HAUP
 284 Lakeside Ln
 CATALINA LAKES
 SAFFORD NC 27332
 DECK EXPANSION
 910-578-0436

DECK EXPANSION →
ADD SCREEN PORCH
TO EXISTING DECK

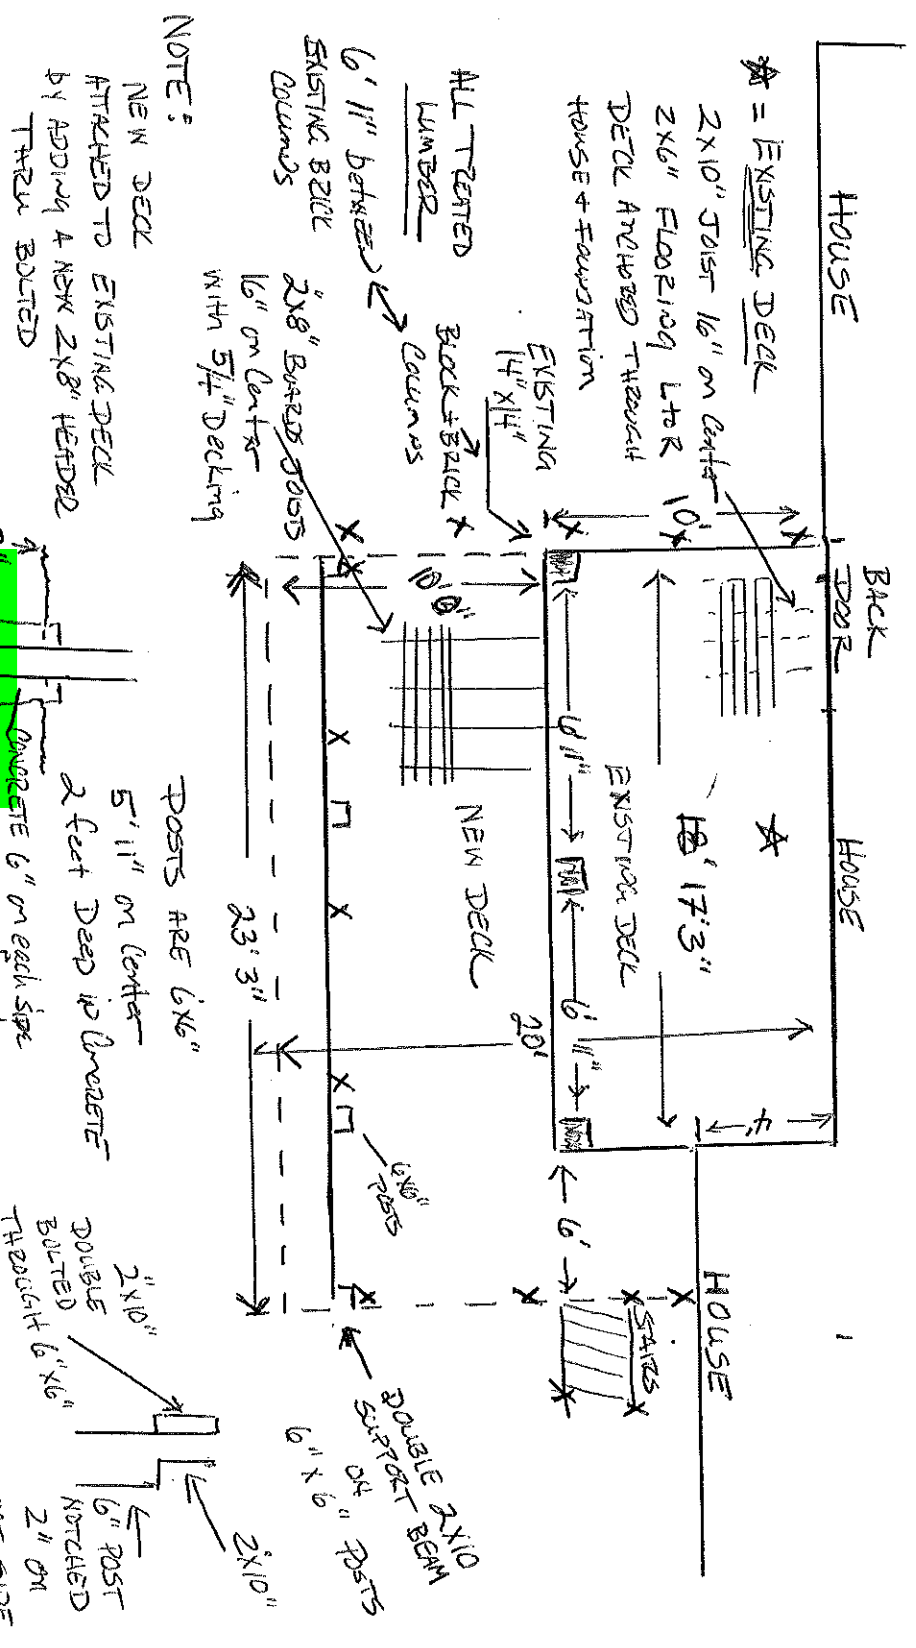
See Notes

All posts must be on a footing per NCRC Appendix "M"

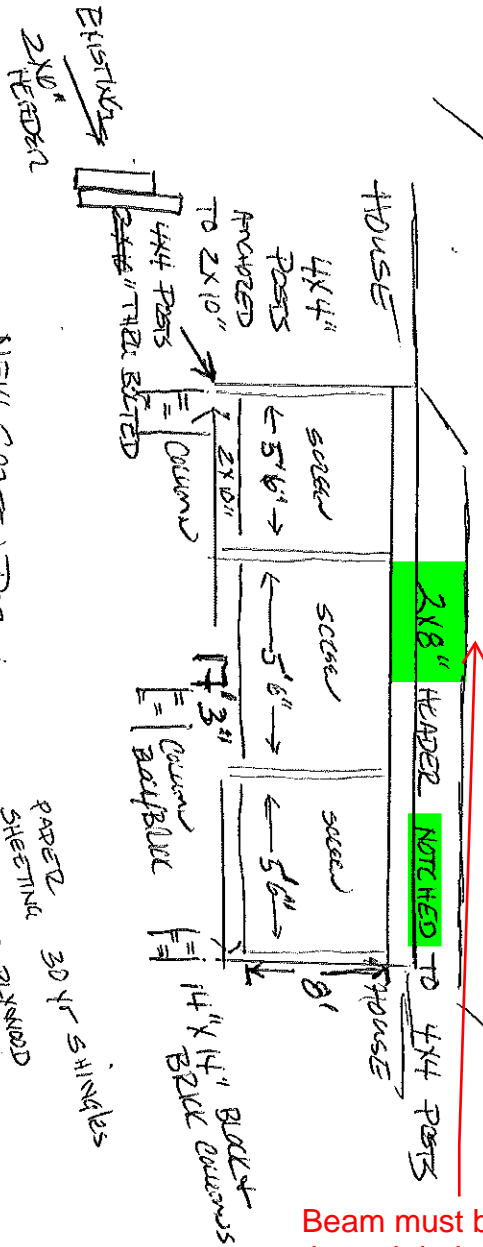
Beam must be 2 ply through bolted to posts. Do not notch post or beam.
